See comments from  
engineering in blue

# PRELIMINARY/FINAL DRAINAGE REPORT FOR ROMENS SUBDIVISION

OCTOBER 2020

Romens Plan: 96cfs Subcritical 10/12/2020

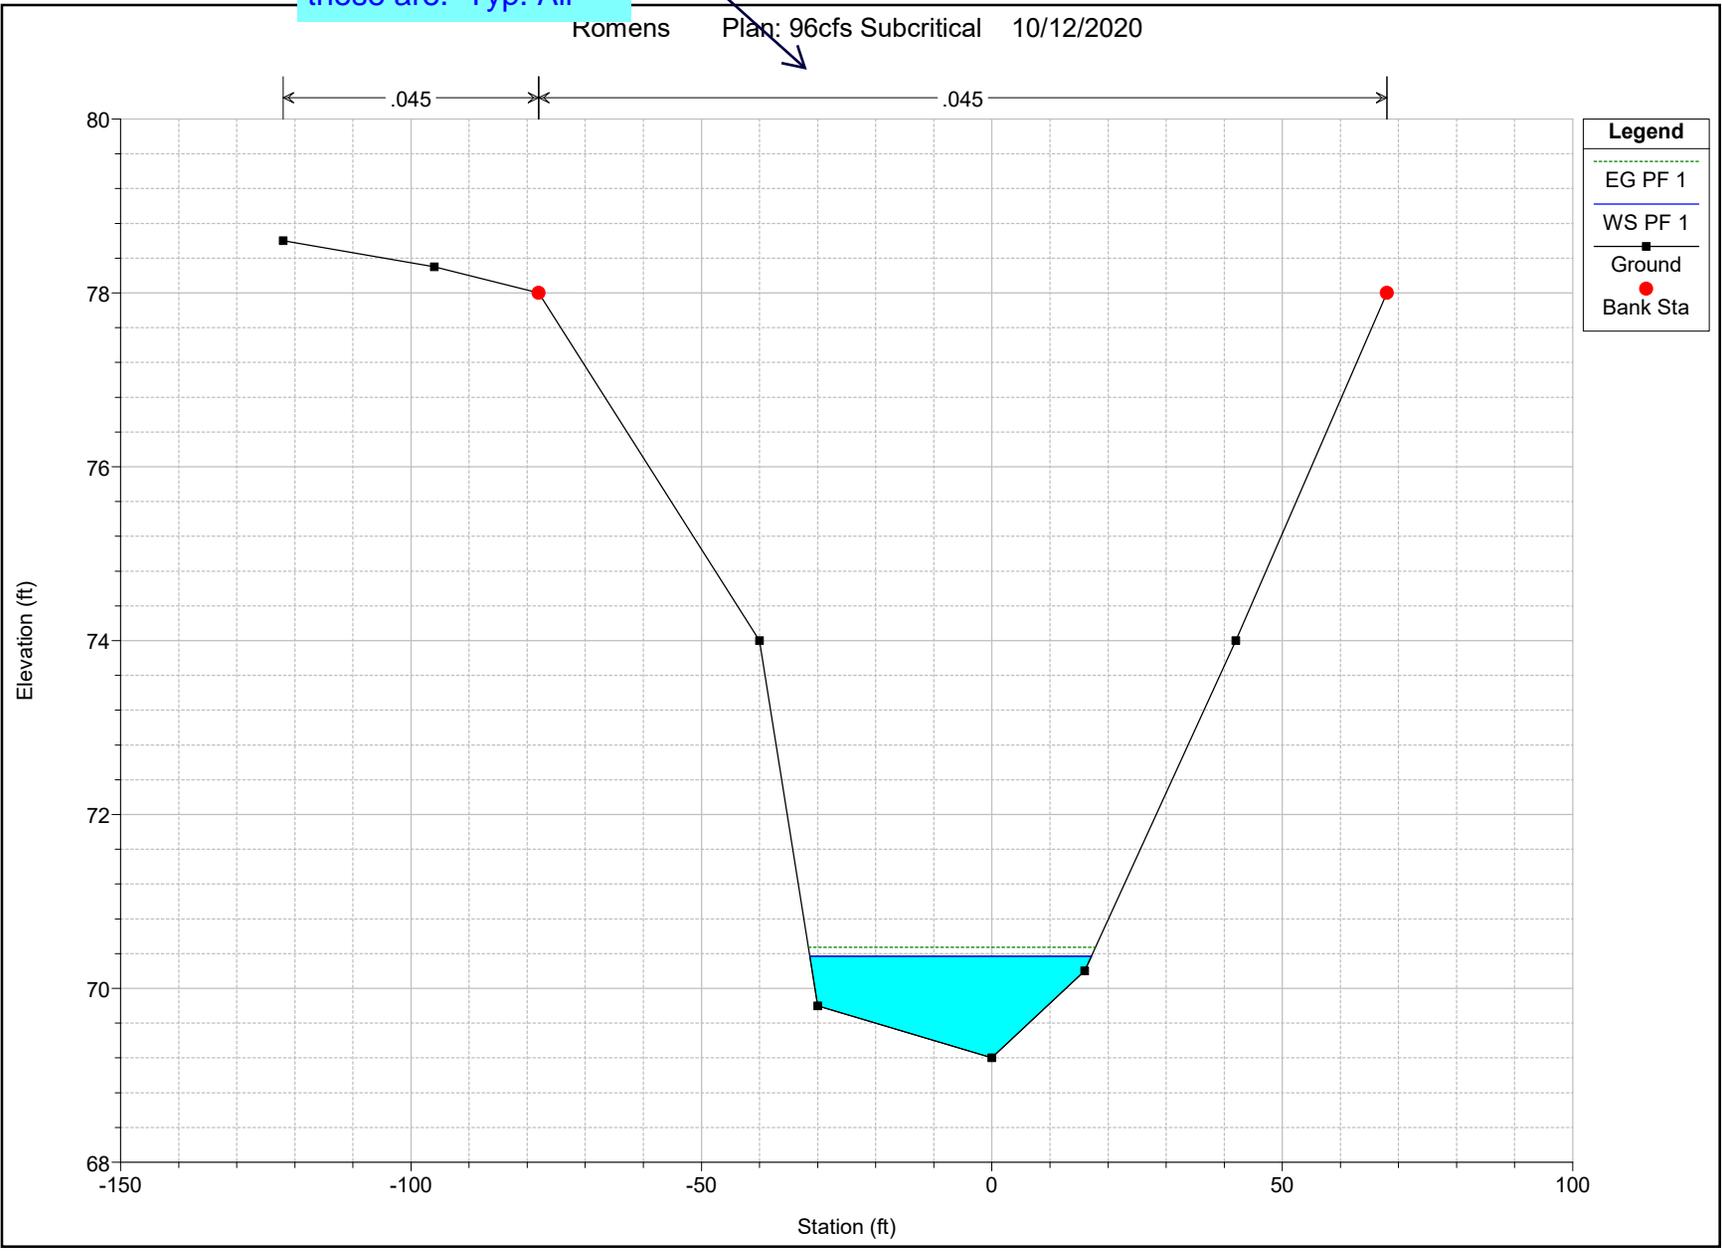
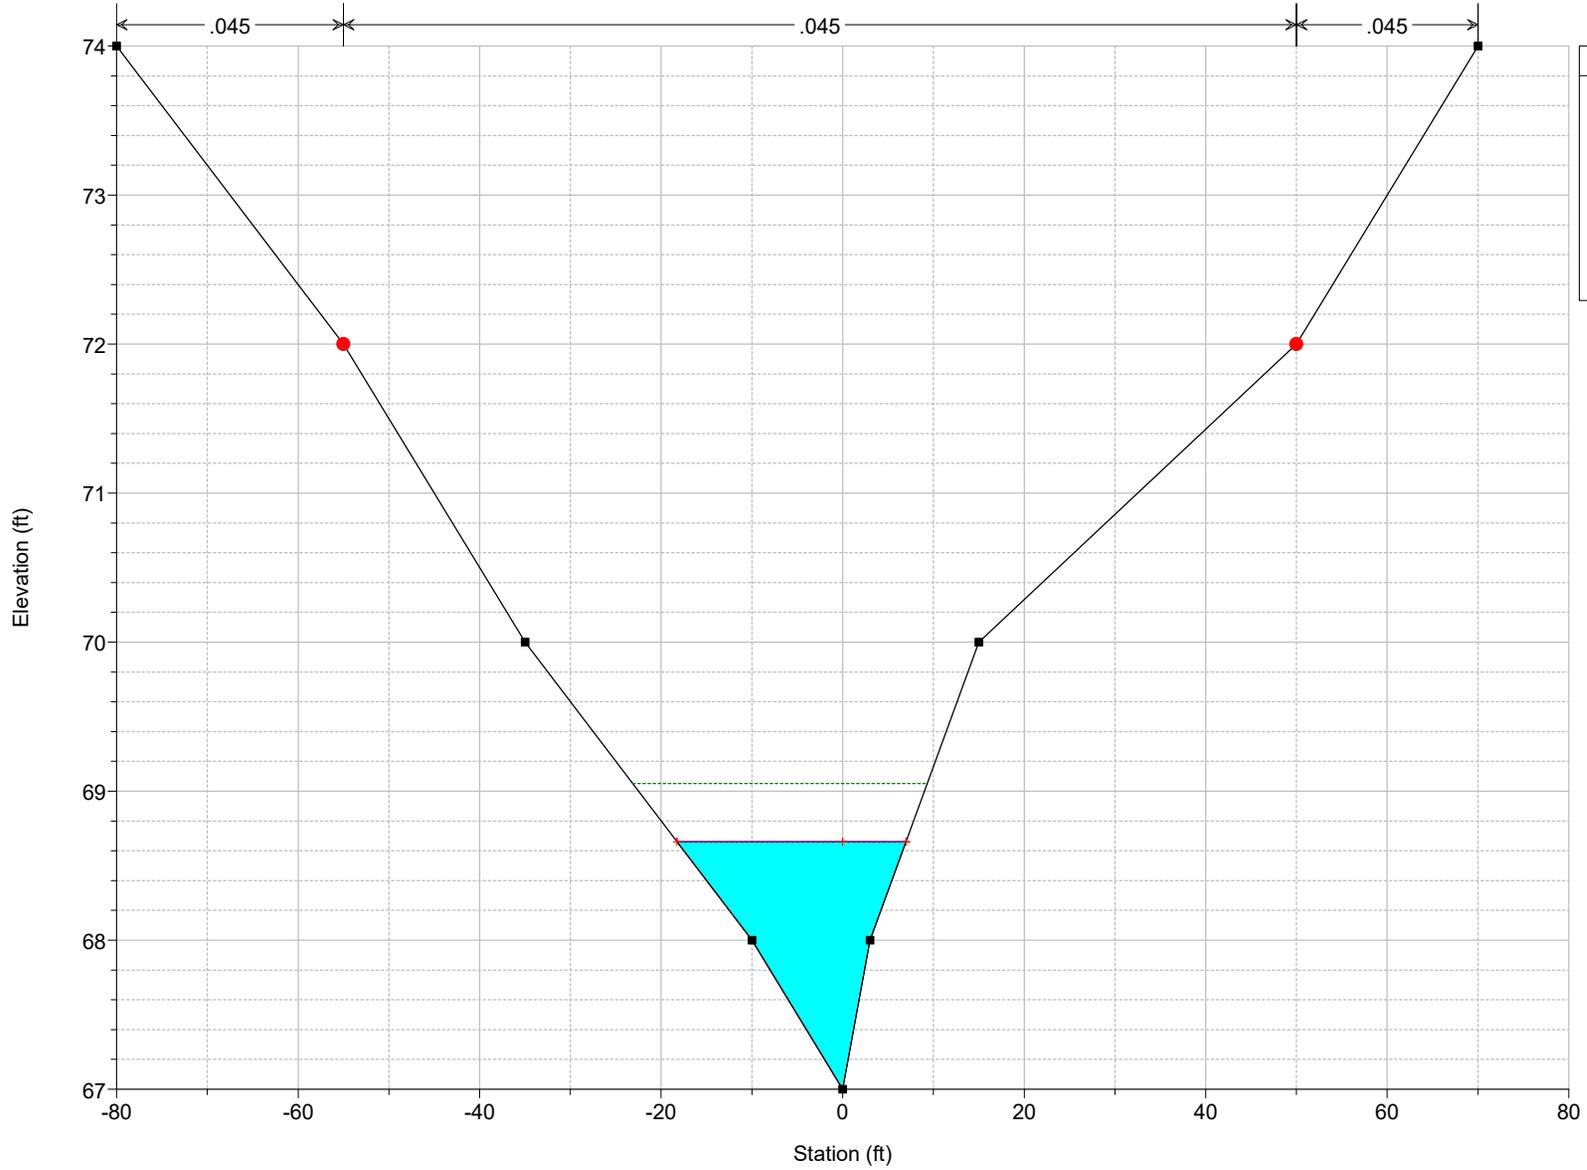
provide the downstream boundary condition used and describe in the narrative.

Provide the table for the other cross sections.

Provide label identify which cross section these are. Typ. All

**ROMENS SUBDIVISION**  
**DRAINAGE PLAN**

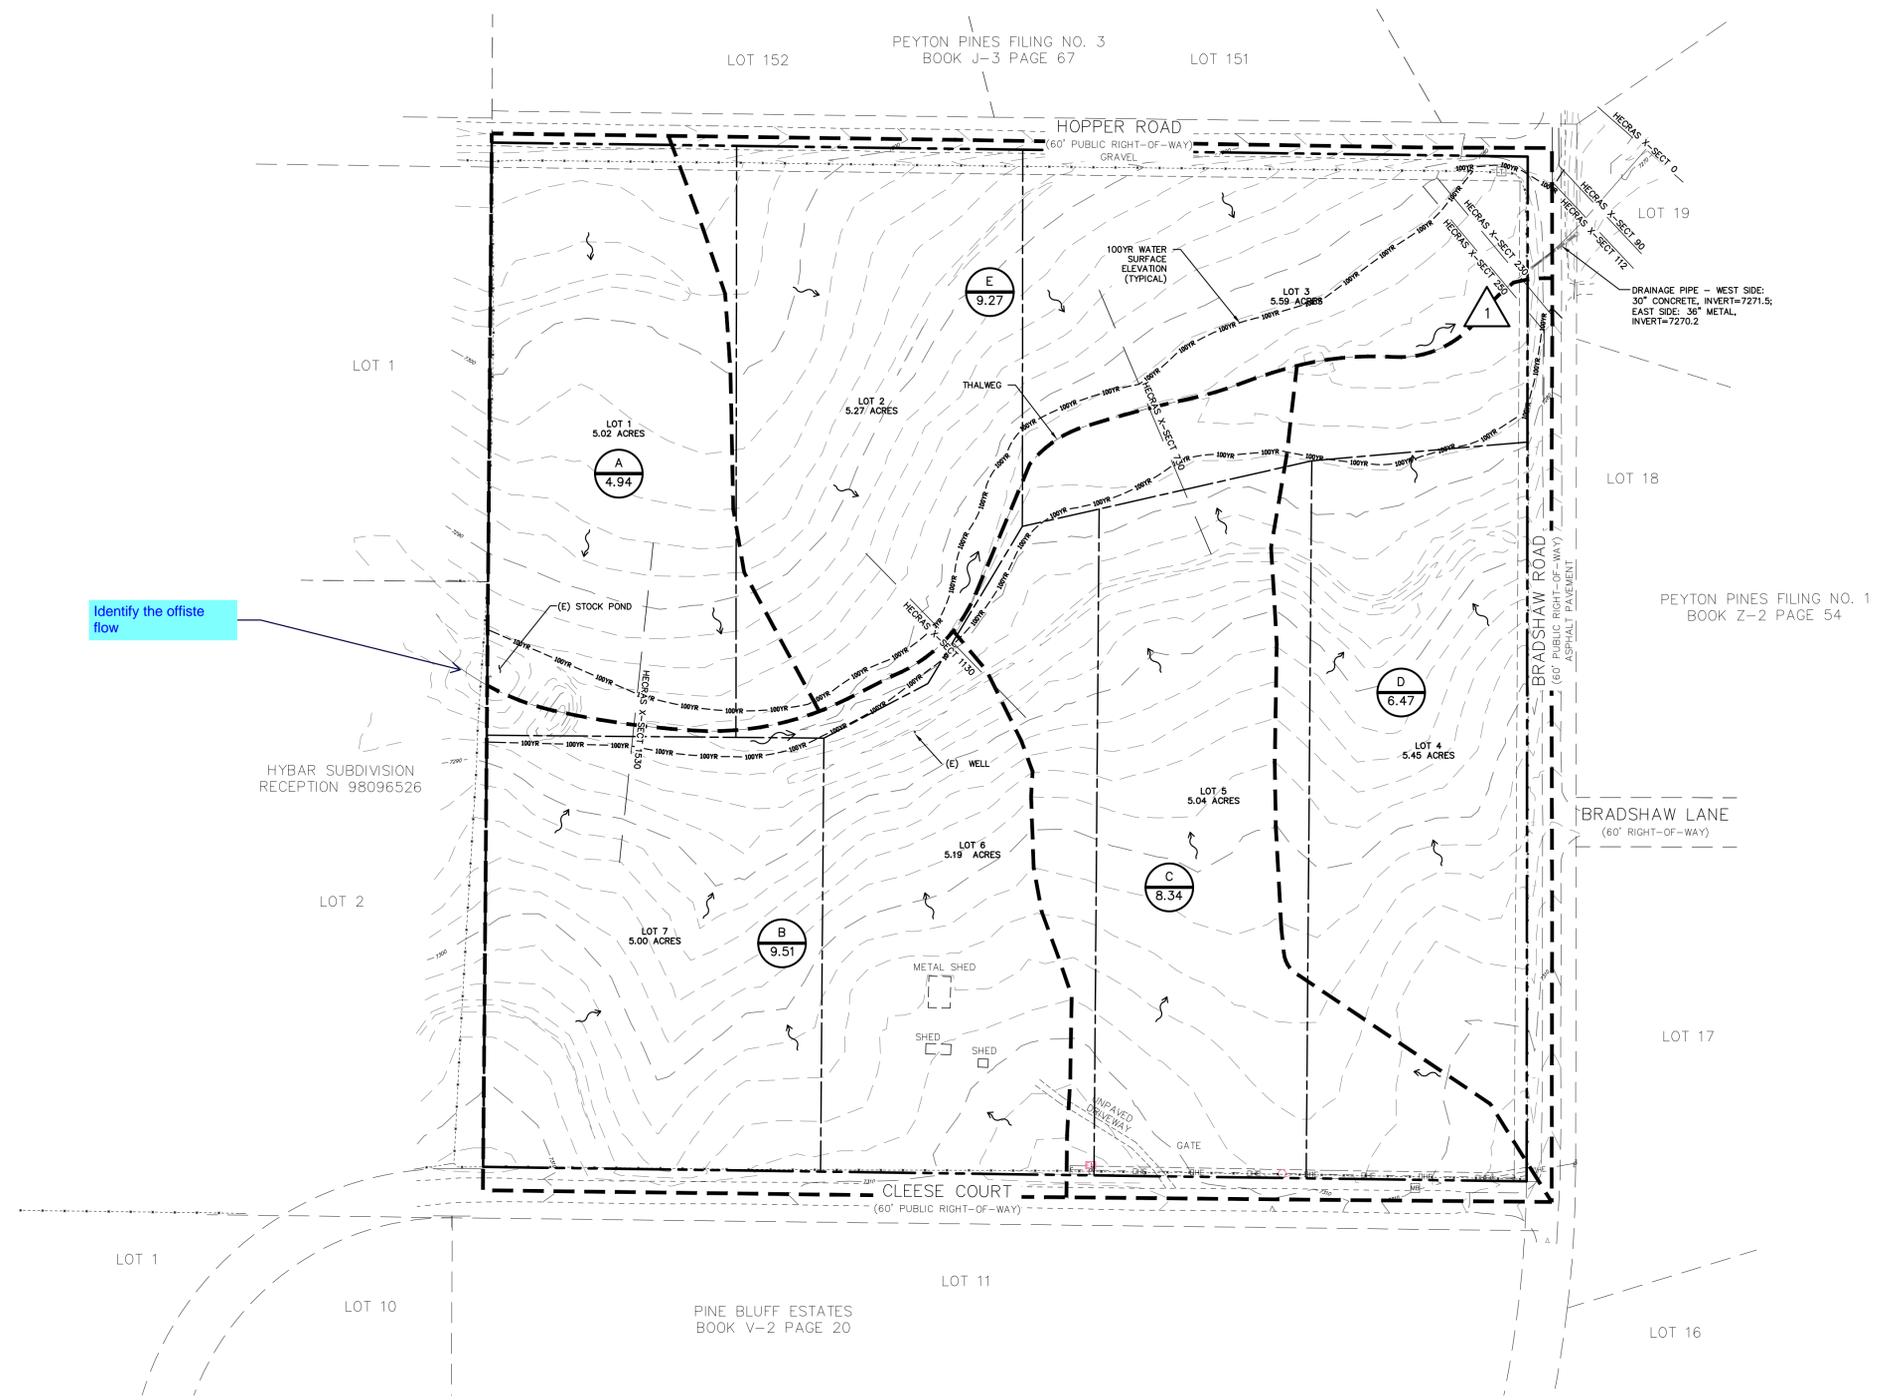
Show time of concentration paths on drainage map.

Identify the offsite flow

Include the offsite flow.
